## Subject: Discontinuation Notice of Your Products

Part No.	Description
IDK-1107WP-50WVA1E	7" LED PANEL 500N with P-cap touch, 800x480(G)

Proposed Replaced Model: IDK-1107WP-50WVB1 (7" LCD, 800x480, 500N, NB W/PCAP TS)

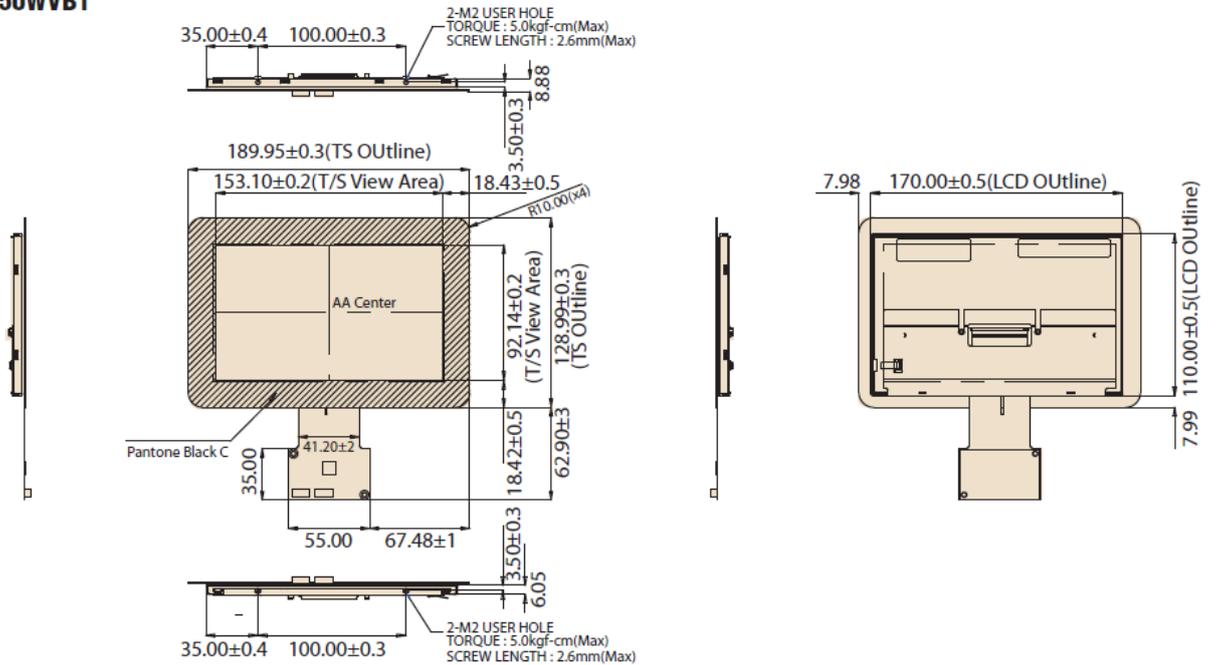
Model		IDK-1107WP-50WVA1E	IDK-1107WP-50WVB1
LCD Panel	Display Size	7", Wide Screen	←
	Resolution	800 x 480	←
	Technology	Normally White	Normally Black
	Viewing Angle (U/D/L/R)	60° /60° /70° /70°	89° /89° /89° /89°
	Brightness (cd/m2)	500	←
	Backlight Life (hrs)	50,000	←
	Contrast Ratio	600:1	800:1
	Response Time (ms)	16	25
	Colors	6 Bit (262K)/8 Bit (16.2 M)	6 Bit (262K)/8 Bit (16.7 M)
	Voltage	3.3 V Power	←
	Consumption	3.56 W	2.48W
	Signal Interface	1 channel LVDS	1 channel LVDS
	Weight	160 g	182.8 g
	Dimensions (W x H x D) (mm)	165 x 104 x 9.53	170 x 110 x 6
Touch Screen	Touch Screen0	Projected Capacitive	←
	Transparency	90± 3%	←
	Surface Hardness	7H	←
	Cover Lens dimension (mm)	187.60 x 126.64	189.5 x 128.99
Environment	Operating Temperature	-20 ~ 70° C	←
	Storage Temperature	-30 ~ 80° C	←

## IDK-1107WP-50WVA1E

## IDK-1107WP-50WVB1
